Technical Memorandum 8-60

HUMAN FACTORS ENGINEERING EVALUATION
OF THE
M60 MAIN BATTLE TANK

Kermit D. Foster

June 1960

Fig. 1. Octave band measurements of the noise in the turret of the M60 Tank at 30 mph and 10 mph

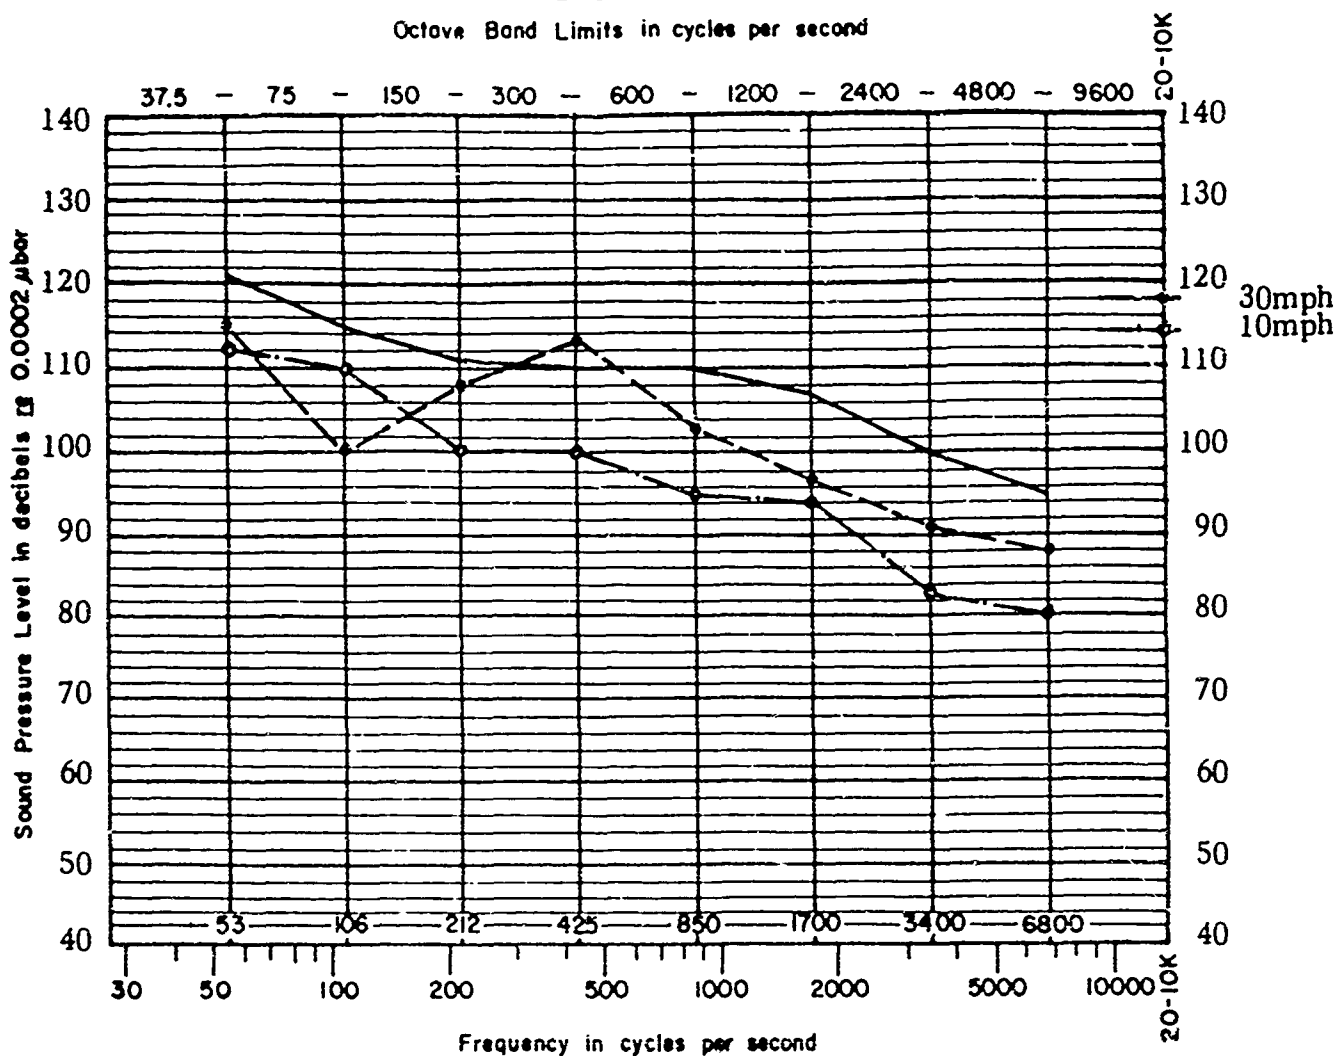
An octave band analysis of noise in the turret at speeds of 30 mph (high range) and 10 mph (low range) was also conducted. At 500 cycles per second, the sound pressure level exceeds the Human Engineering Laboratories' maximum sound pressure level standard for that octave band by 3 db. This deviation from the recommended limit is negligible and no action, in terms of additional sound attenuation, is recommended.
